# 2015 SOUTH GATE EDUCATIONAL CENTER MASTER PLAN SUPPLEMENTAL FINAL ENVIRONMENTAL IMPACT REPORT

THE LOS ANGELES COMMUNITY COLLEGE DISTRICT

NOVEMBER 2016

## **SUPPLEMENTAL FINAL ENVIRONMENTAL IMPACT REPORT**

See updated **Figure 4.6.3**.

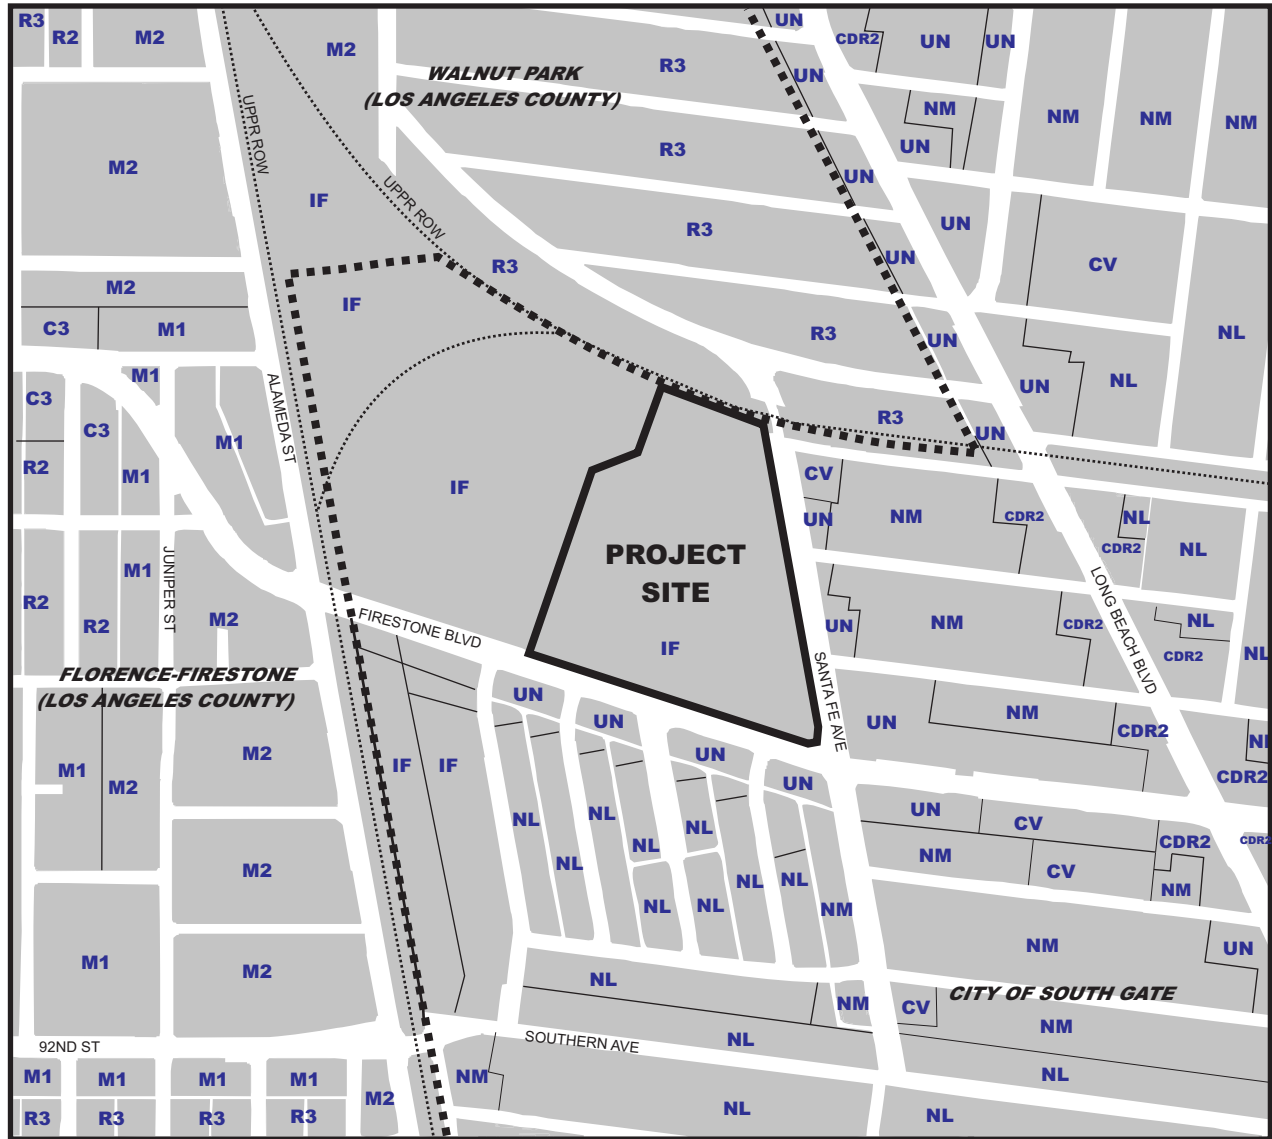
- Supplemental Draft EIR page 4.6-7, replace **Figure 4.6.3**.
